SUBJECT: Forwards Suppl 2 to XN-NF-84-72, "Large Break LOCA-ECCS Analysis W/Increased Enthalpy Rise Factor:K(Z) Curve" & revised Tech Spec Page 3.10-22, reflecting substituted K(Z) curve, per 840723 request re. Cycle 10.

H. B. ROBINSON STEAM ELECTRIC PLANT, UNIT NO. 2
DOCKET NO. 50-261/LICENSE NO. DPR-23
SUPPLEMENTAL REQUEST FOR LICENSE AMENDMENT - CYCLE 10
REVISED K(Z) CURVE

Figure 3.10-3

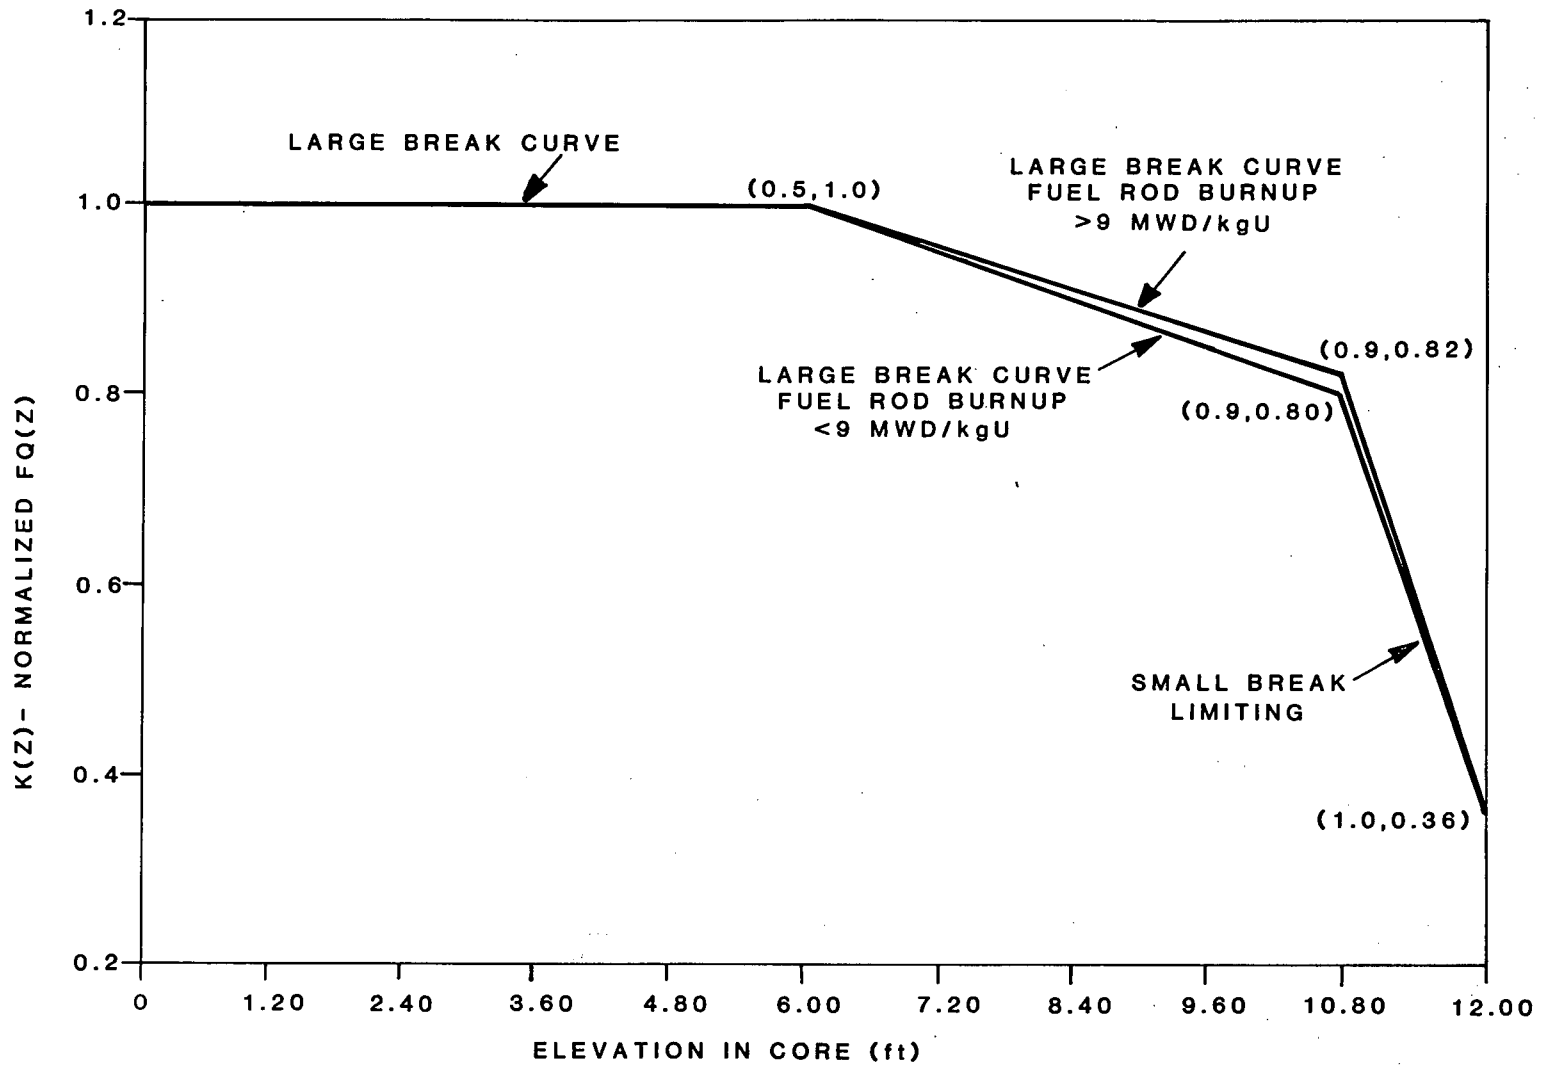
By letter dated July 23, 1984, Carolina Power & Light Company (CP&L) provided the NRC with the plans for operation of the H. B. Robinson Steam Electric Plant Unit No. 2 (HBR2) during Cycle 10 and requested revisions to the Technical Specifications (TS) for HBR2. Confirmatory analyses performed following that submittal indicated that a change to the previously submitted K(Z) Curve was required. This letter provides a substitute K(Z) Curve for that submitted previously.

While confirming the analyses which produced the original K(Z) Curve, it was determined that in the event of a LOCA it would be possible to exceed a peak clad temperature (PCT) of 2200°F. Reanalyses have produced a more conservative curve which meets the criterion for PCT remaining below 2200°F during LOCA events. Because the new curve is more conservative than the original, CP&L believes prenoticing is not required.

Please find attached a revised page 3.10-22 which replaces the previous page 3.10-22 submitted with our July 23, 1983 TS request. Should you have any questions regarding this matter please call Mr. Sherwood R. Zimmerman at (919) 836-6242.
